RE: San Patricio Townhomes
1512 San Patricio SW
Permanent C.O. - Accepted
Engineer's Certification Date: 6/17/20
Engineer's Stamp Date: 8/15/19
Hydrology File: K13D078

RE: 1512 San Patricio Ave. SW
BP-2019-20564

As-Built

New Dwelling
SITE PLAN / COVER

SITE PLAN GRADING AND DRAINAGE

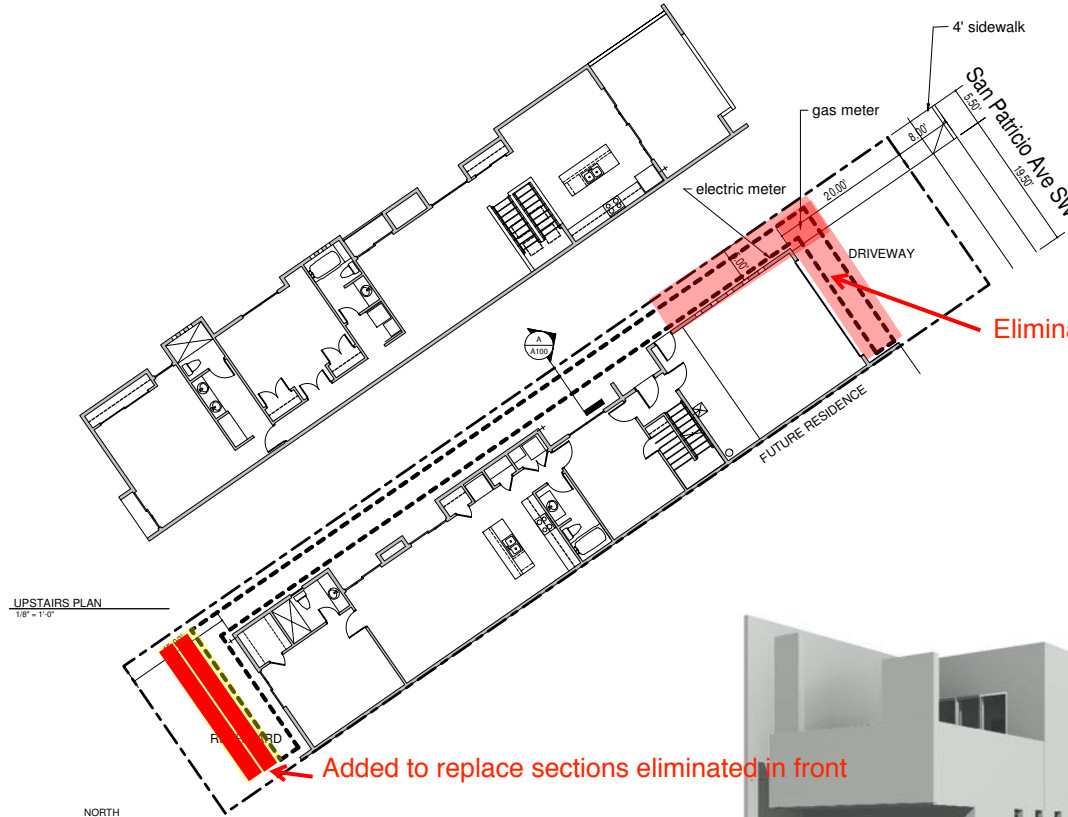
AS-BUILT DEVIATION: The approved design called for 140 linear feet of trenching and pipe, which was installed. However, the location of forty linear feet of trenching and pipe needed to be moved from the front and side/front to the rear of the lot as depicted in the attached as-built drawing. The as-built configuration provides for the exact same volume of retention.

Eliminated due to conflict with utilities
